Access Compliance Report

Public Rights-of-Way

Intersection ID: 32038	Main Street: COLONY_RD	Cross Street: WISLEY_BV	Location: NW
ADA ID: A1F537C53938	Ramp Type: Perp	Initial Pass/Fail: Fail	Overall Compliance: No
Severity Score: 21.25			
Codes/Mitigation Info/Possible Solution		Field Measurements/Component Compliance

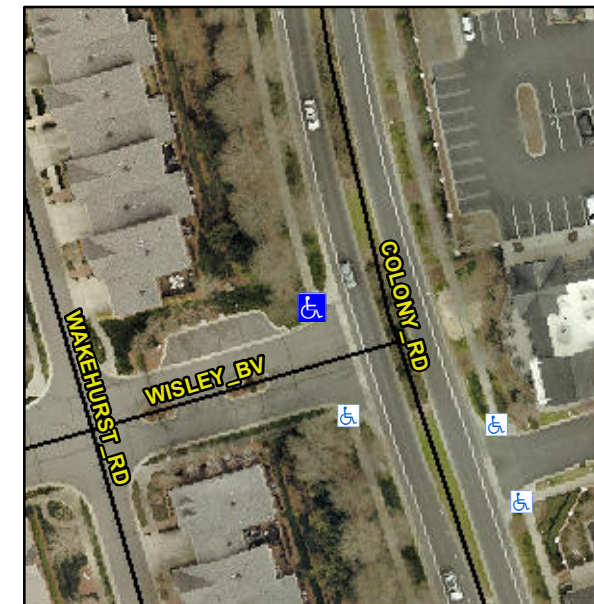
Not Found, R304.5.1, R304.5.3

Compliance	Description	Data	Compliance	Description	Data
N/A	Ramp Length (in)	76.0	Yes	Ramp Slope (%)	5.3
No	Ramp Width (in)	40.0	No	Ramp XSlope (%)	5.5
N/A	Flare Type LT	N/A	N/A	Flare Type RT	N/A
N/A	Flare Slope LT (%)	N/A	N/A	Flare Slope RT (%)	N/A
N/A	Flare Traversable LT?	N/A	N/A	Flare Traversable RT?	N/A
N/A	Landing Length (in)	N/A	N/A	DWS Provided?	N/A
N/A	Landing Width (in)	N/A	N/A	DWS Contrast?	N/A
N/A	Landing Slope (%)	N/A	N/A	DWS Length (in)	N/A
N/A	Landing X Slope (%)	N/A	N/A	DWS Full Width?	N/A
N/A	Landing Curb? (Y/N)	N/A	N/A	DWS Offset (in)	N/A
N/A	Shared Landing?	N/A			
N/A	Gutter Ponding?	N/A	N/A	Gutter Slope (%)	N/A
N/A	Gutter Lip Ht (in)	N/A	N/A	Gutter X Slope (%)	N/A
N/A	Painted X Walk1?	No	N/A	Painted X Walk2?	N/A
	X Walk 1 Direction	To S		X Walk 2 Direction	N/A
N/A	X Walk 1 Width (in)	N/A	N/A	X Walk 2 Width (in)	N/A
	X Walk 1 Slope (%)	0.6		X Walk 2 Slope (%)	N/A
	X Walk 1 X Slope (%)	4.4		X Walk 2 X Slope (%)	N/A

Remove & Replace Entire Ramp.
